Ship's Name S.S. "MANCHESTER EXPORTER".

Official No. 140584.

Memorandum of alterations reported since ship was surveyed for assignment of Load Lines in

MANCHESTER 9th JUNE, 1945.

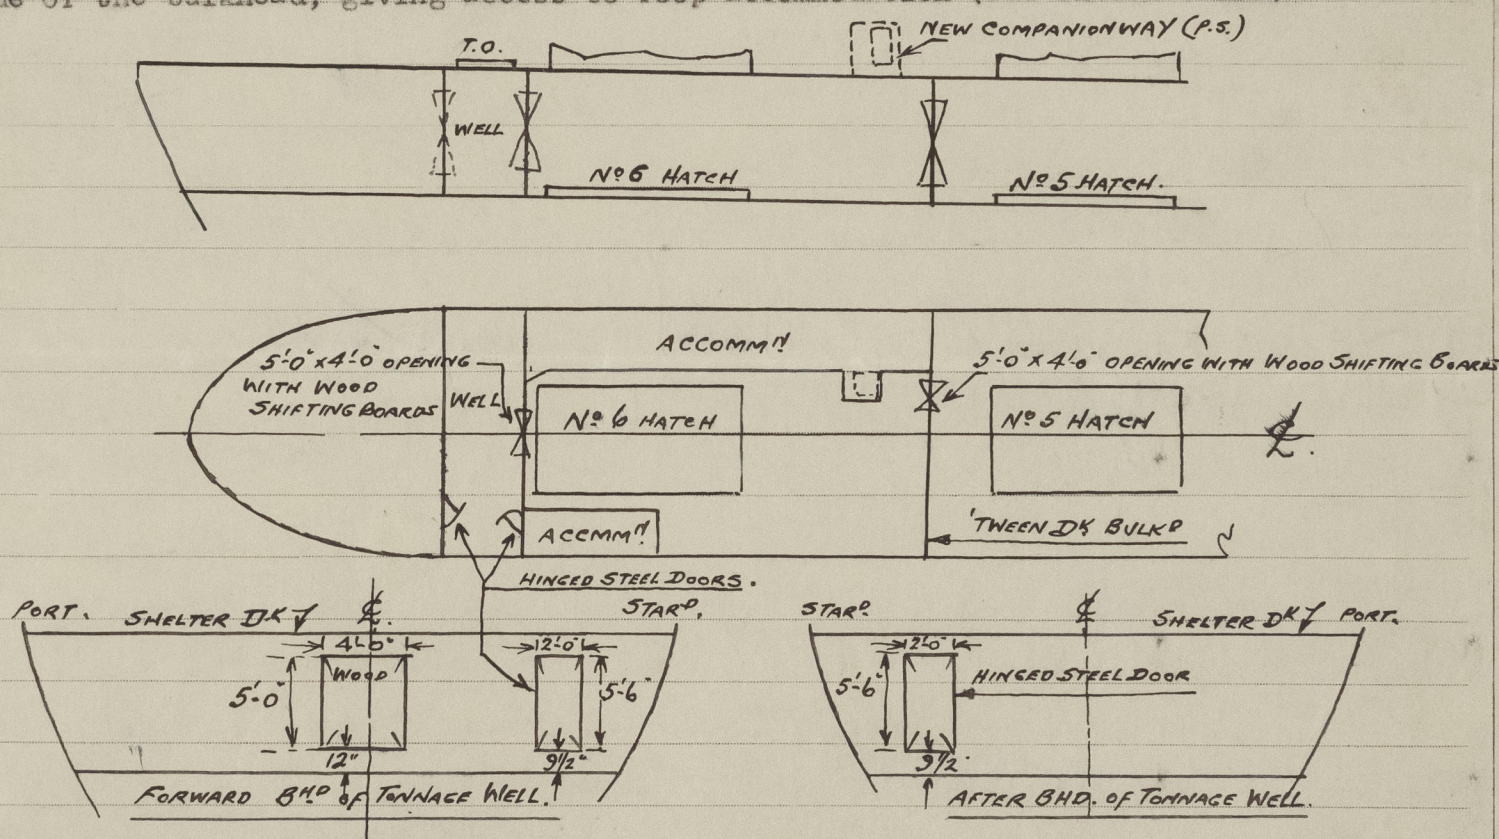
FORWARD BULKHEAD OF TONNAGE WELL:- An opening 5'-0" x 4'-0" closed by 3" wood shifting boards in channels welded to bulkhead has now been fitted on the centre line, and an opening 5'-6" x 2'-0" closed by means of a strongly constructed steel hinged door manipulated from both sides has been fitted on the starbd. side of the bulkhead, giving access to new accommodation (see sketch below).

AFTER BULKHEAD OF TONNAGE WELL:- An opening 5'-6" x 2'-0" closed by means of a strongly constructed steel hinged door manipulated from both sides has been fitted to the starbd. side of the bulkhead, giving access to Poop accommodation (see sketch below).

'TWEEN DECK BULKHEAD BETWEEN NOS. 5 AND 6 HATCHWAYS:- This bulkhead has been retained and an opening 5'-0" x 4'-0", closed by 3" wood shifting boards in channels welded to bulkhead, fitted off to Port Side (see sketch). *Grain slots cut at wings J.B.M. 14/6/46*
